April 30, 2019

**ADDENDUM NO. 4**

**#15036 – FORD FIELDS CONCESSION STAND  
BEAUMONT, TEXAS**

1  
SK-2 **ENLARGED WEST ELEVATION (COVERED WALKWAY)**

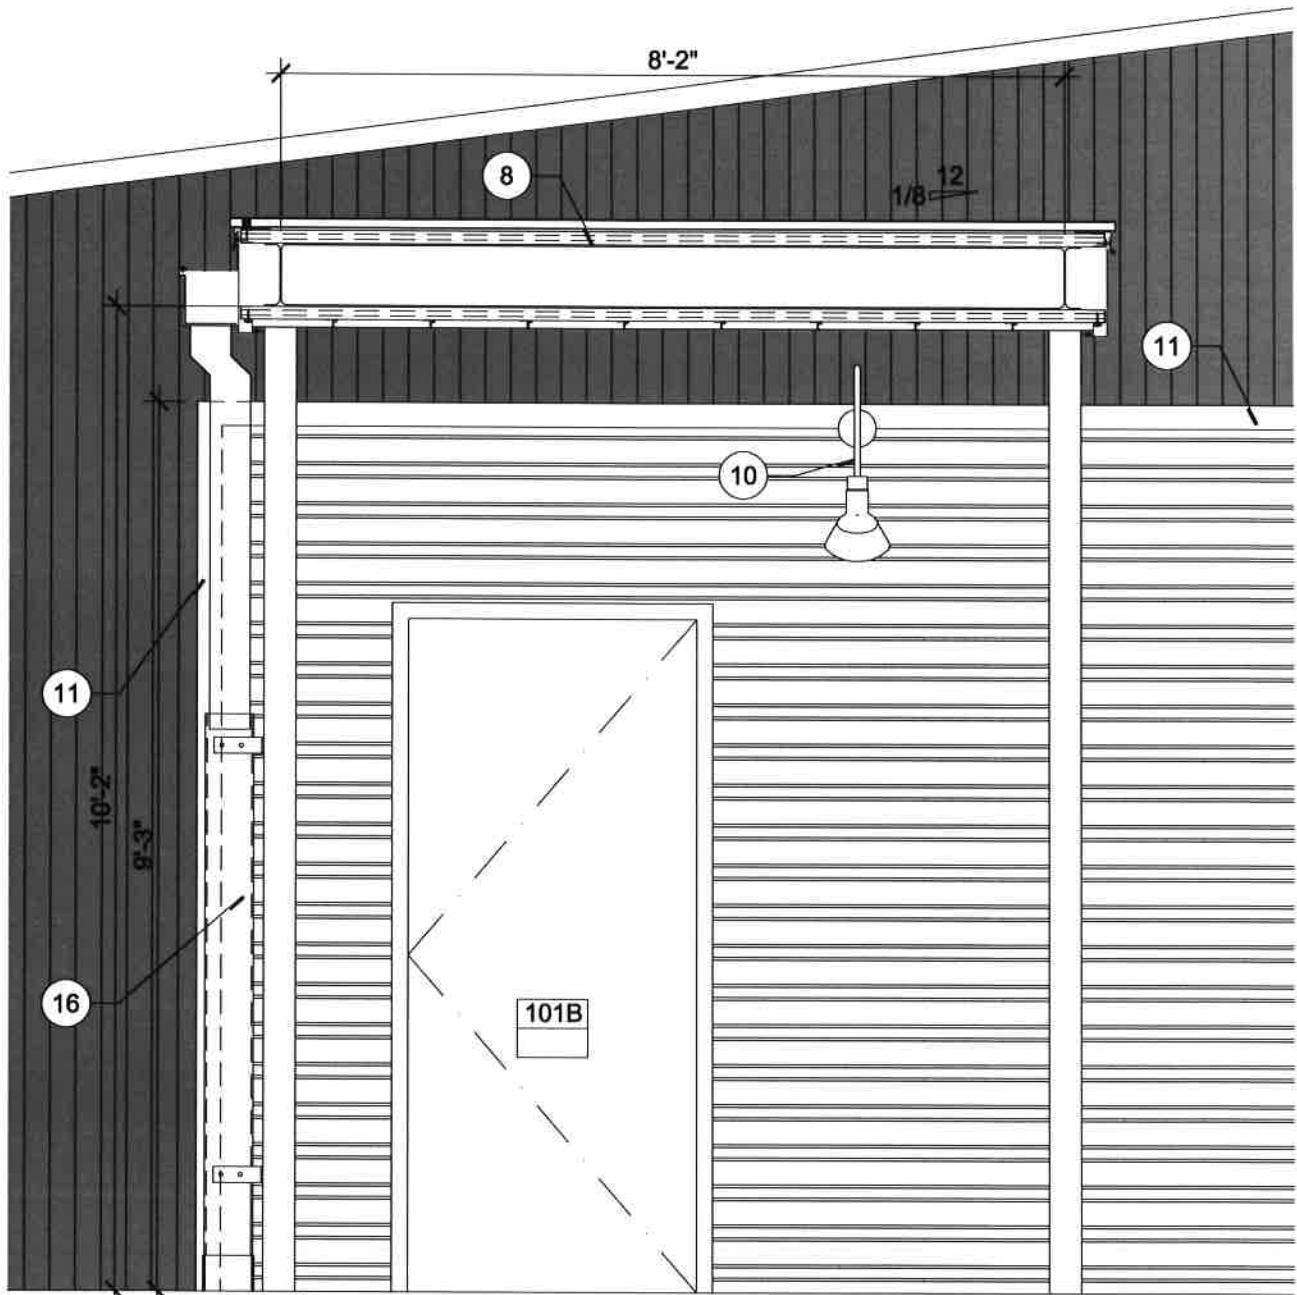
1. SK-2 shall be included on A3.0 as an enlarged section of the Covered Walkway shown on 4/A3.0
